Response to a Second Request for Additional Information Regarding ANP-10284, "U.S. EPR Instrumentation and Control Diversity and Defense-In-Depth Methodology Topical Report" (TAC No. MD5884)

Response to Second Request for Additional Information – ANP-10284
“U.S. EPR Instrumentation and Control Diversity and Defense in Depth [D3] Methodology
Topical Report” (TAC No. MD5884)

Figure RAI 18-1: Process Automation System (Diverse Actuation Subsystem)

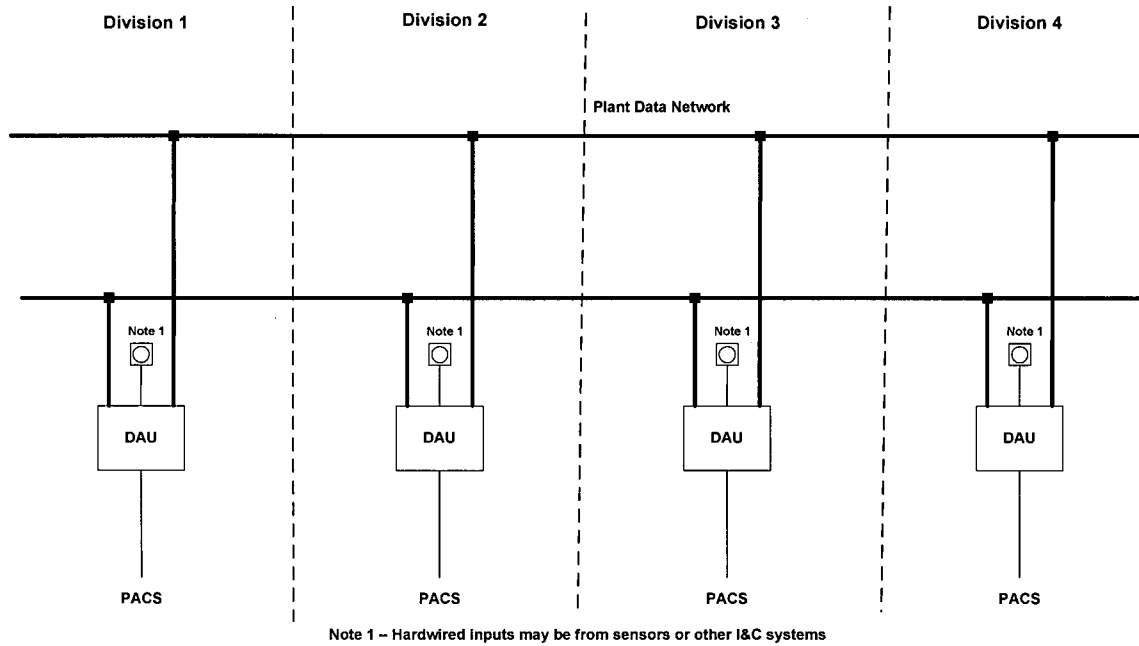
RAI-18: *What is the architecture of the DAS as it relates to the PAS? Is the DAS implemented on its own hardware/software component within the PAS system, or is it implemented on the same hardware as other PAS functions as a particular software function? Please provide detailed explanation.*

The DAS is organized in four redundant divisions located in separate Safeguards Buildings. Each division of DAS contains diverse actuation units (DAU). The arrangement of the DAS is shown in Figure RAI 18-1. Hardwired signals can be acquired from sensors or other I&C systems. The method of acquiring signals from the Protection System (PS) is described in RAI-19 response. Fiber optic data connections are provided to share trip requests, and two out of four voting is done in each DAU. Outputs are sent to the Priority and Actuator Control System (PACS) via hardwired connections. The DAU's interface with the Process Information and Control System (PICS) via the plant data network for the display of information.
